Dealer Service Instructions for:

Safety Recall P70 / NHTSA 14V-711 Seating Capacity Label

2014 - 2015 (JC) Dodge Journey

Figure 1 – Driver’s Side “B” Pillar

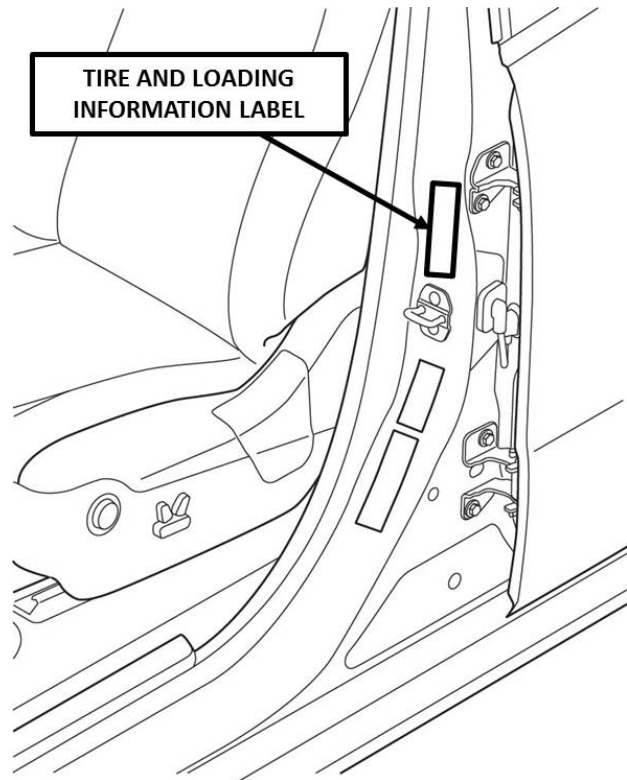
1. Open the driver’s door and locate the Tire and Loading Information label on the driver’s side “B” pillar as shown in Figure 1.
2. Clean the existing Tire and Loading Information label with alcohol / glass cleaner or equivalent and a soft cloth to remove any dirt, oil residue or grease.
3. Remove the overlay label from its paper backing and carefully install it over the seating section of the Tire and Loading Information label (Figure 2). Firmly press and smooth the overlay label to the surface of the existing Tire and Loading Information label to ensure good adhesion.

Figure 2 - Tire and Loading Information Label with Overlay

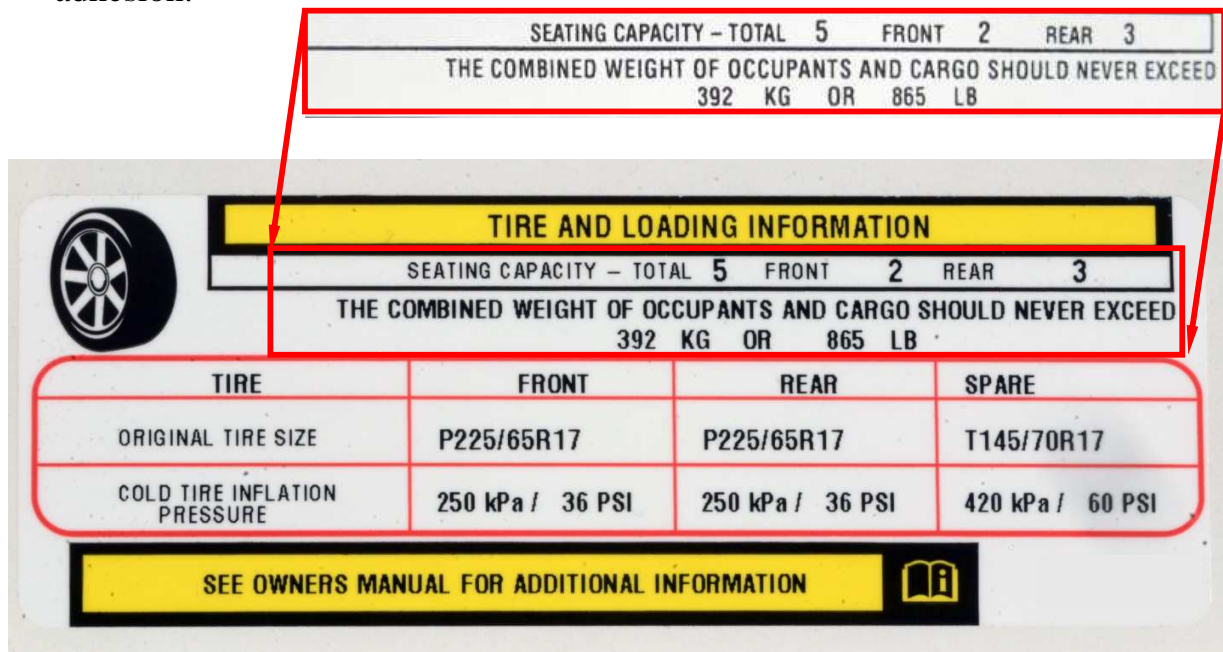
The Seating Capacity label on about 660 of the above vehicles fails to conform to the requirements of Federal Motor Vehicle Safety Standard (FMVSS) No. 110, "Tire Selection and Rims for Motor Vehicles with a GVWR of 10,000 pounds or less". The labels contain incorrect seat capacity information. This can cause improper loading of the vehicle and result in a crash without warning.

Dealers are required to apply an Overlay label to the Tire and Loading Information label on all involved vehicles in new vehicle inventory.
